Application number, type . . . : 17 50040951 CP NEW RESIDENTIAL (SFD)
Property address : 94554 *UNASSIGNED

Re: Engineering Services
2665 Ash Ave.
Dunn, NC

Tyndall Project No.: 1701-020196

APPLICATION # 1750040951
JOB NAME Rayford McCloud
DATE PLANS RECEIVED 6.3.17
SITE PLANS APPROVED Approved w/exception
APPROVED BY HS *WJ*

FIRST FLOOR PLAN

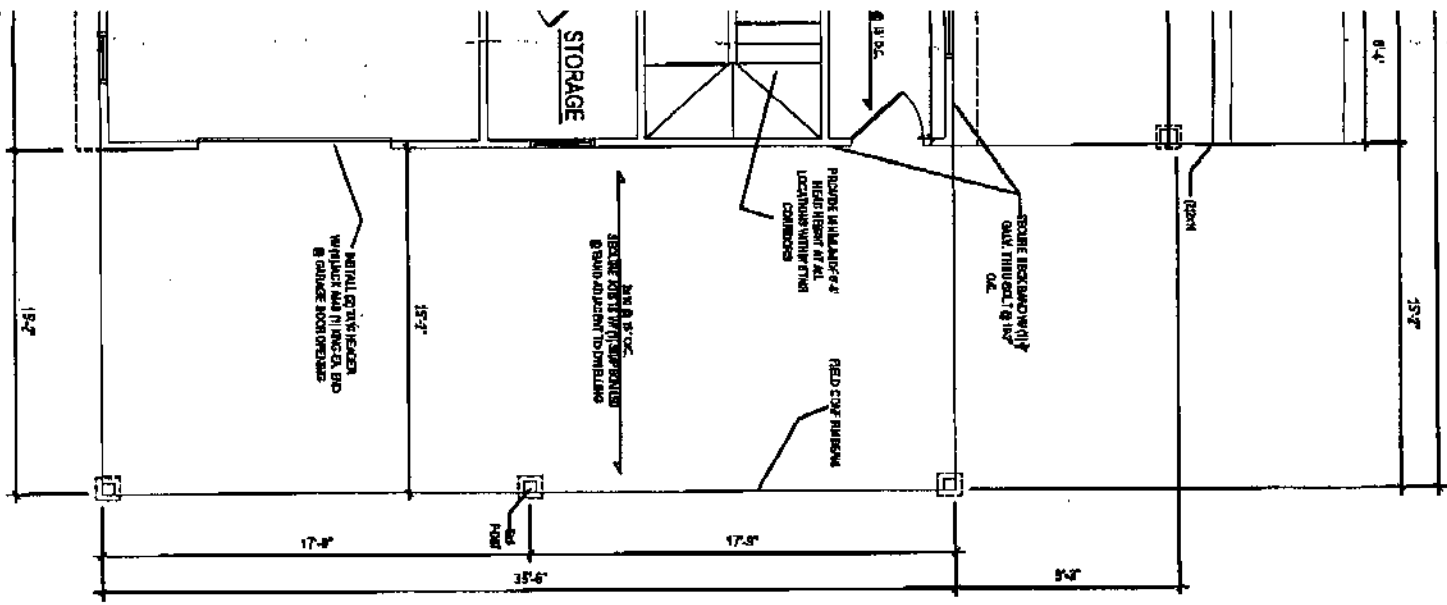
- 1) Floor joists associated with the ground floor were noted as being approximately 8" above the existing crawlspace grade. The existing floor joists were noted as being untreated 2x8 SYP joists placed at 16" O.C.
- 2) Untreated wooden girder members placed in direct contact with masonry associated with the girder support.
- 3) No means of foundation ventilation provided for crawlspace.
- 4) Minimum head height requirements (6'-8") not met at steps leading from 1st floor To 2nd floor.
- 5) Minimum head height requirements not met at 2nd landing encountered during ascension to 2nd floor.
- 6) Header not installed at single car garage door opening.
- 7) 1st floor wall studs 2x4 @ 16" O.C. in-lieu of code 2x6 for 3-story residential structure.

- 8) 4ft. Cantilever (2x10 floor joists) @ 3rd floor balcony.
- 9) Can't confirm roof support beam at covered porch roof located on right side of dwelling.

- 1) The joists' proximity to the finished grade does not meet the intent of the NC Residential Building code. TE&D recommends that this condition be addressed with the implementation of one (1) of the following options:

- a) Remove the existing subfloor to allow access to the floor joist. Apply a wood sealant/preservative product (such as Woodlife Coppercoat Wood Preservative) in accordance with all manufacturer recommendations.

- b) Remove the existing untreated floor joists and replace them with treated members.
- 2) Provide metal flashing between the bottom of the floor joists and the top of the masonry units so that no direct masonry/wood contact remains.

- 3) The foundation should be provided with a means of foundation ventilation. Non-typical vents (such as soffit vents) may be installed through the masonry foundation block. Based on our observations and analysis, approximately 64 sq. in. of ventilation is required. The recommended foundation vents should be installed on at least two (2) sides of the existing foundation.

- 4) This condition occurs at multiple points within the stair corridors. TE&D recommends rebuilding the staircases as necessary to provide minimum head height clearances (6'-8"). Note: Installing a spiral staircase may be an option that could be considered for this item.

- 5) Based on our observations and analysis, TE&D recommends that a (2) 2x10 (spf) header be installed at the location in question. Provide one (1) Jack stud and one (1) king stud at each end.

- 7) Based on our observations and analysis, 2x4 wall studs (approx. 7' height) are adequate to support the anticipated loading conditions. No action required.

- 8) TE&D recommends that the backspan and supporting framing be field confirmed so that the joists may be properly analyzed.

- 9) TE&D recommends that the beam be field confirmed so that it may be properly analyzed. Our load estimates indicate that the beam should be on the order of a 3-1/2"x14" Parallam to adequately support the anticipated loading conditions.
